EAGLE MOUNTAIN PLANNING COMMISSION MEETING

October 12, 2021, 5:30 PM

6.A [Action Item - Eagle Mountain Medical Office Building](#)

TITLE:	Action Item - Eagle Mountain Medical Office Building		
ITEM TYPE:	Site Plan		
FISCAL IMPACT:			
APPLICANT:	Jared Pinegar / Bruce Fallon		
GENERAL PLAN DESIGNATION	CURRENT ZONE	ACREAGE	COMMUNITY
		.95	Ranches Gateway

SHEET:
C-1

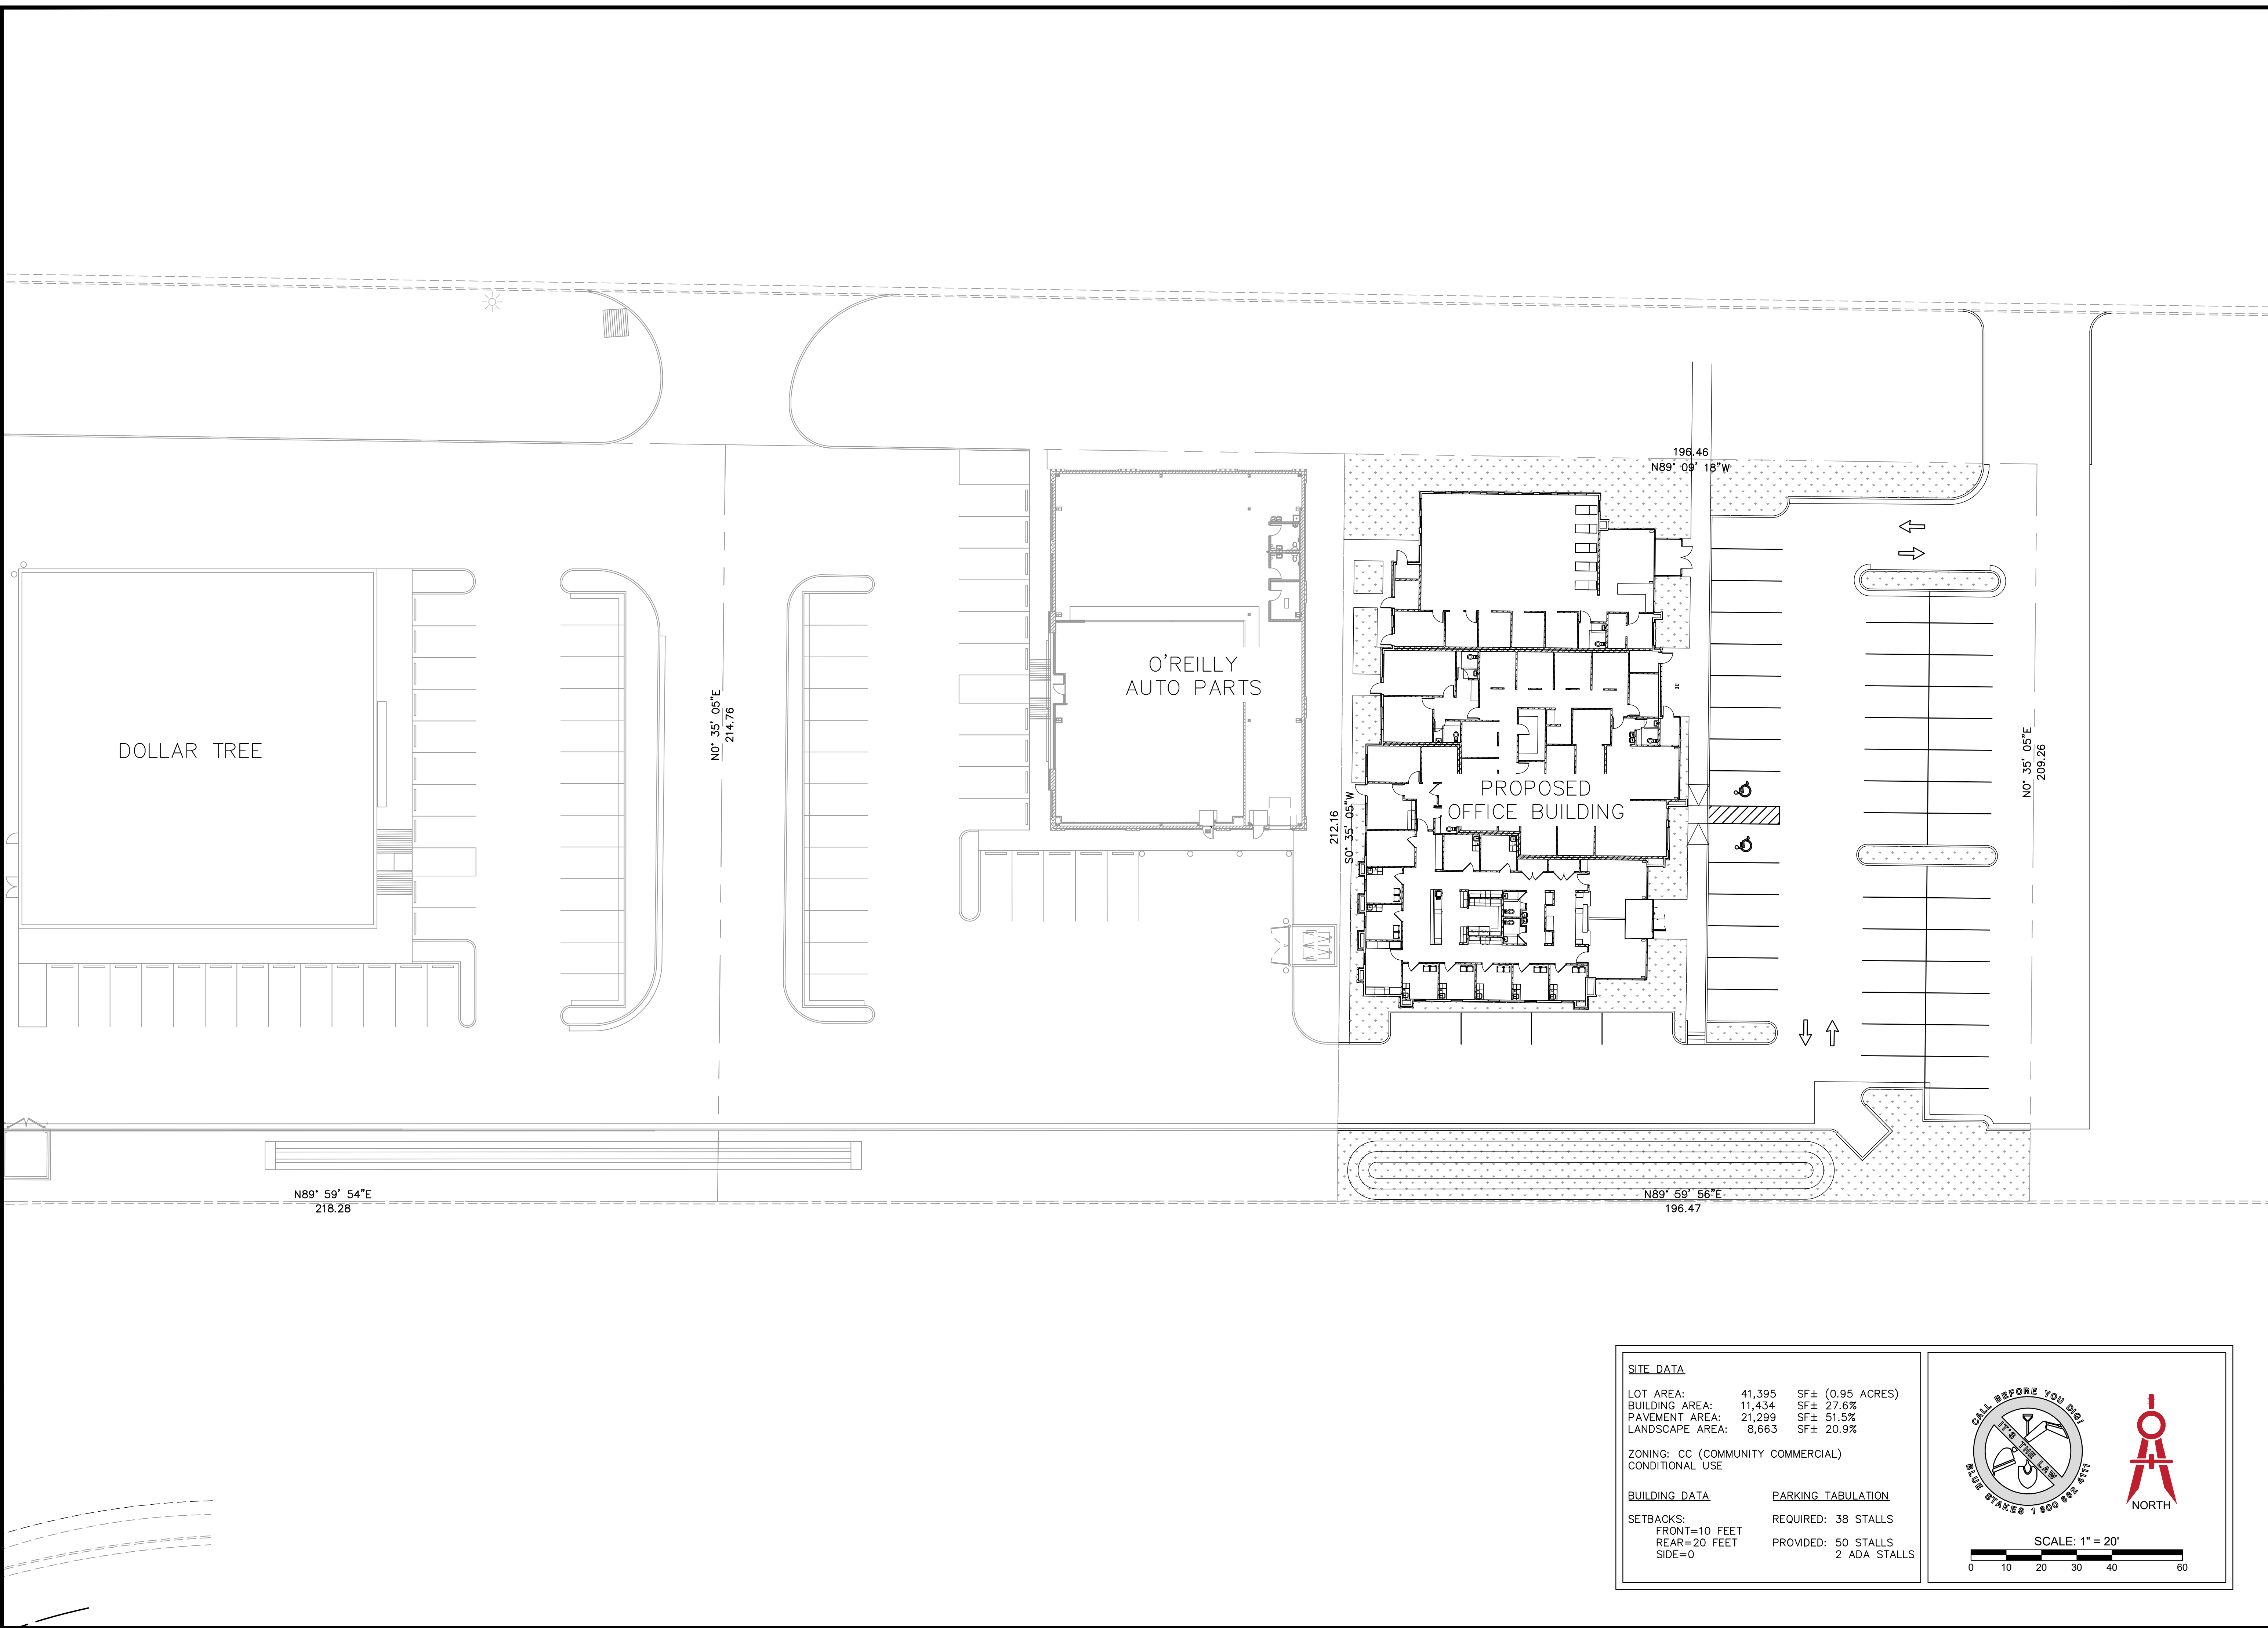
1. Drive aisle at rear of lot be continued to East property line.
2. Additional design elements are added to the North Elevation as required by 17.72.030 A1
3. Additional vertical and horizontal articulation and features on north and west elevations as required by 17.72.040 D
4. Chosen architectural features shall be used on all 4 sides of the building in accordance with 17.72.040 E1
5. Additional materials added to West and North elevations to eliminate featureless surfaces in accordance with 17.72.040 F2
6. LocalScape or other waterwise landscaping is required.
7. Monument Sign shall be located on applicants property.

SHEET:
C-1.1
DATE:
Aug 13, 2021

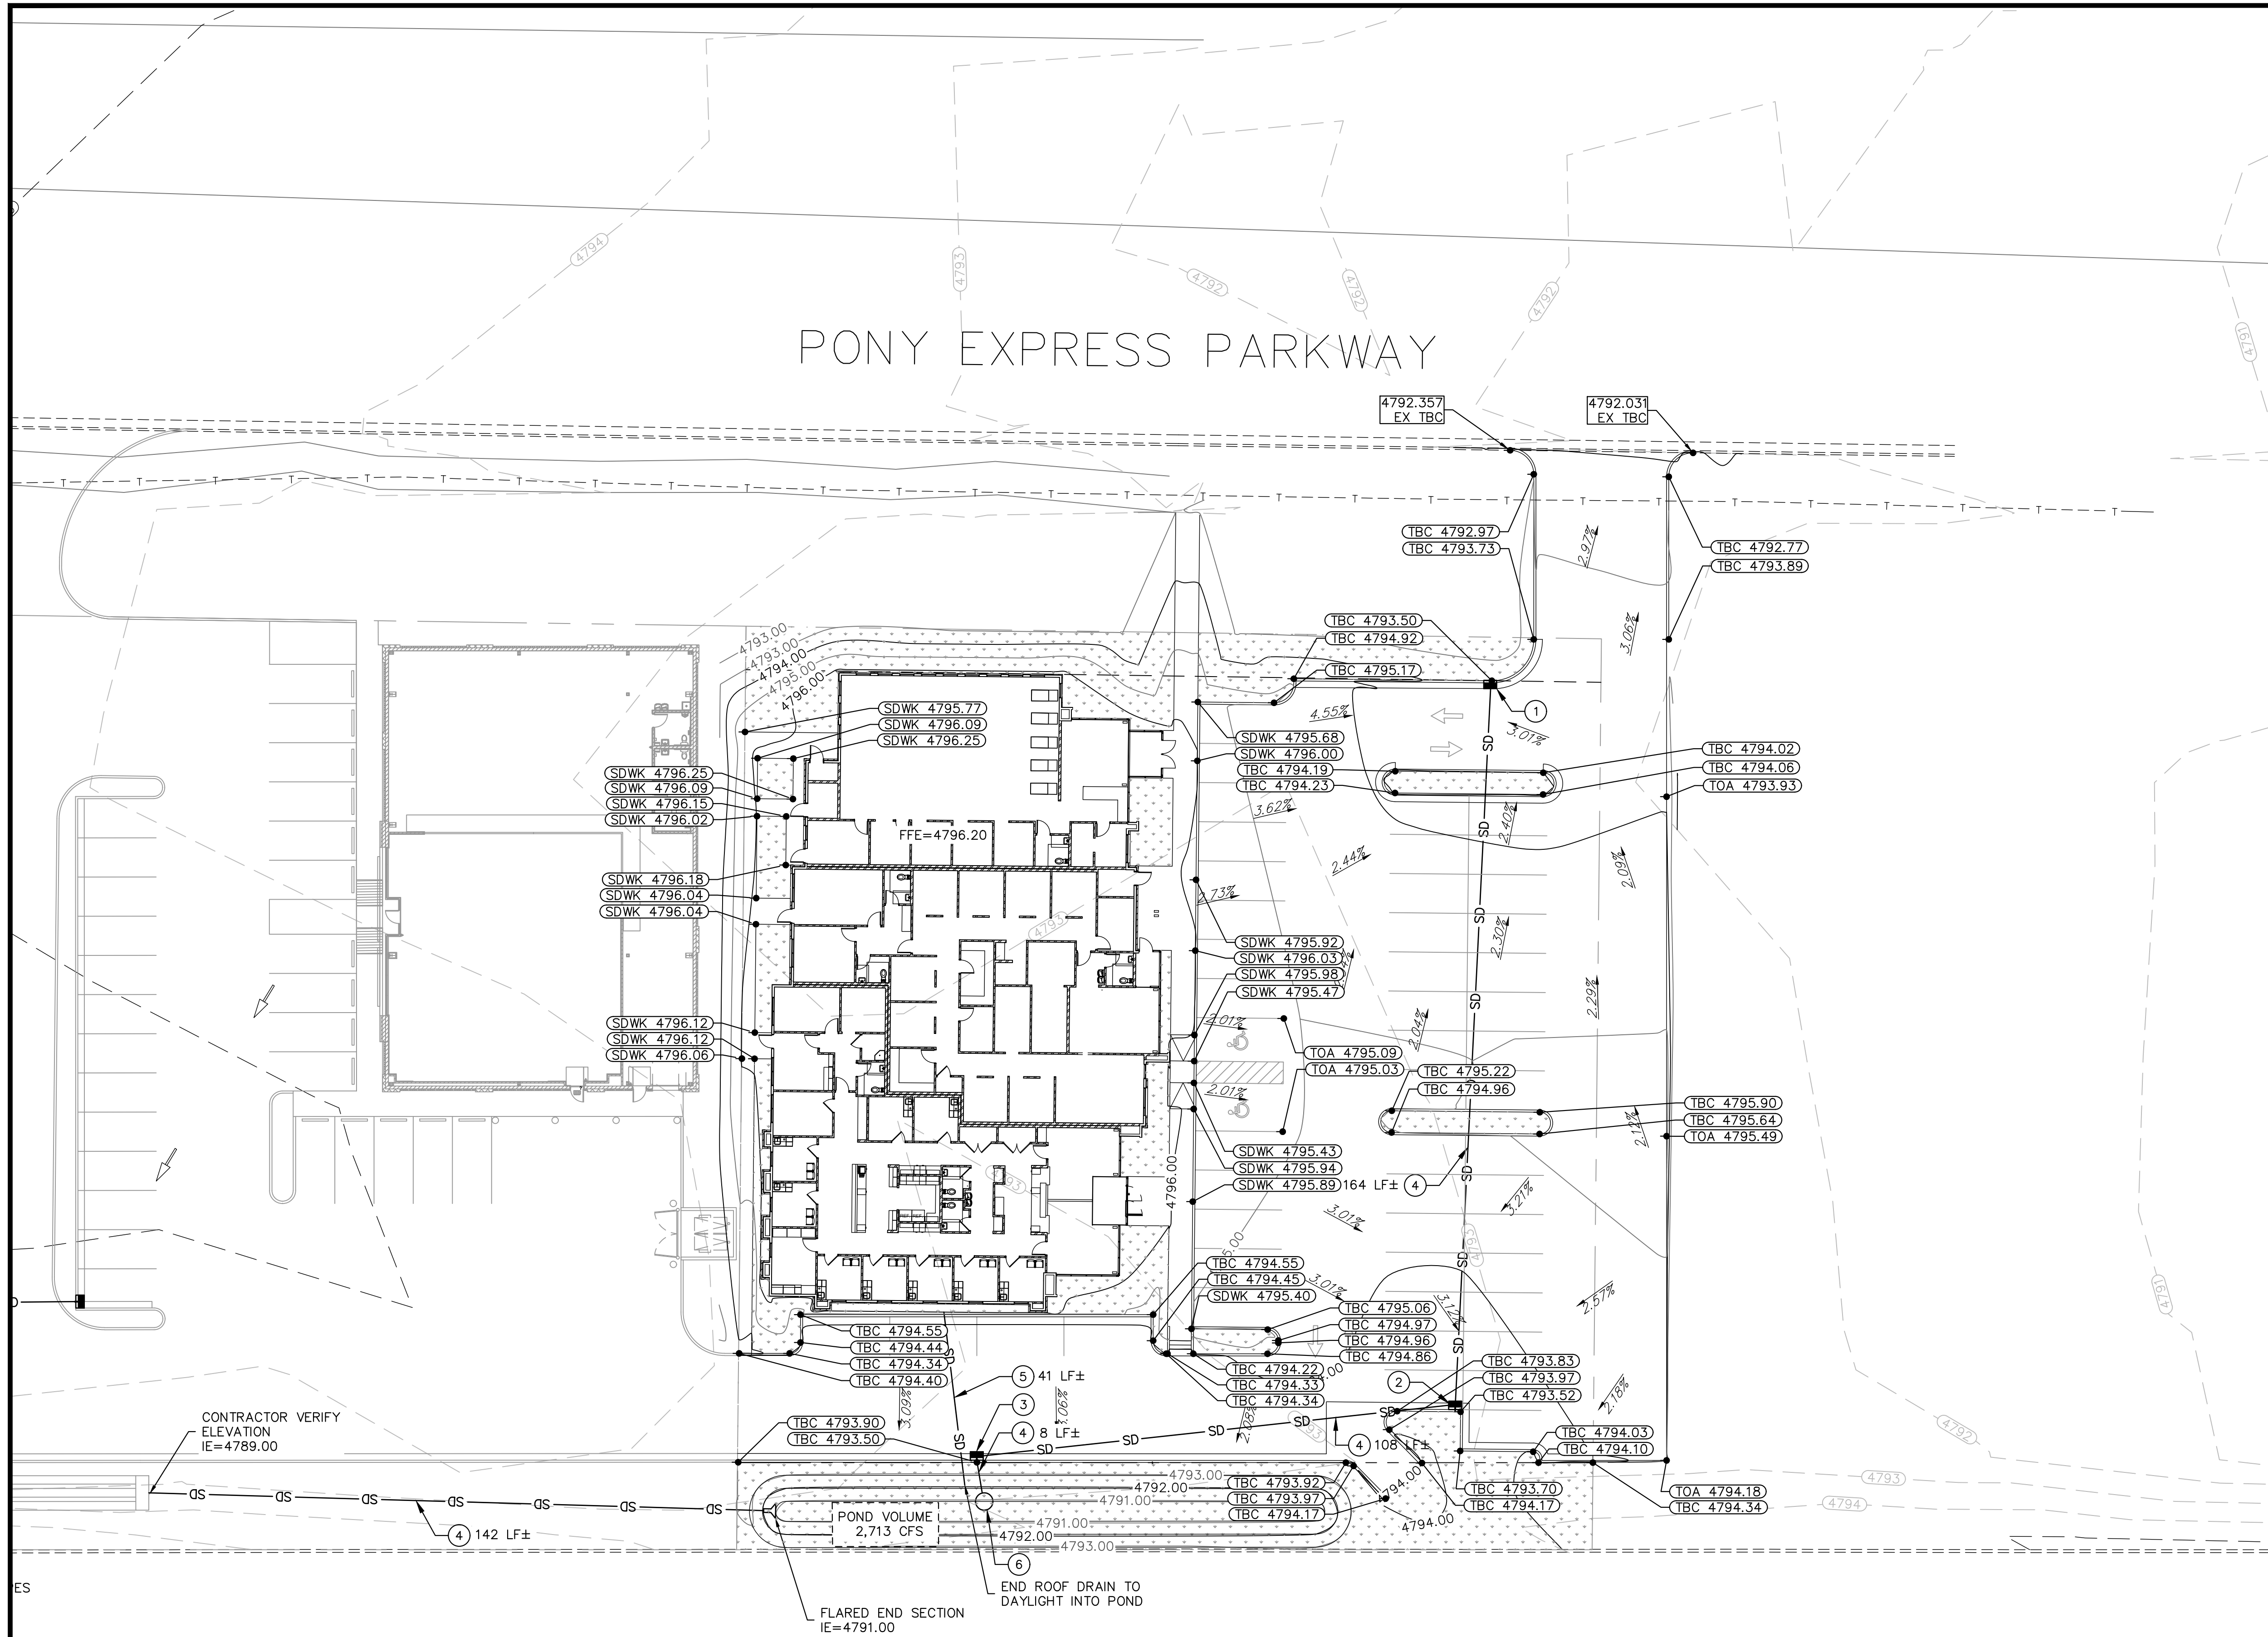
Review of the proposed grading plan shows the elevation at the top back of curb for this project to be 4,793.50' at the lowest point to 4,794.34' at the highest location. While the elevation of the bottom of the six foot (6') wall is 4,793' which provides an effective screen height of 5.5' at the lowest point and 4.66' at the highest point (the East corner of the project) it should be noted the applicant is providing trees and shrubs between the top back of curb and the residential property. The Commission should consider if this screen plan is sufficient to meet the requirements of this section.
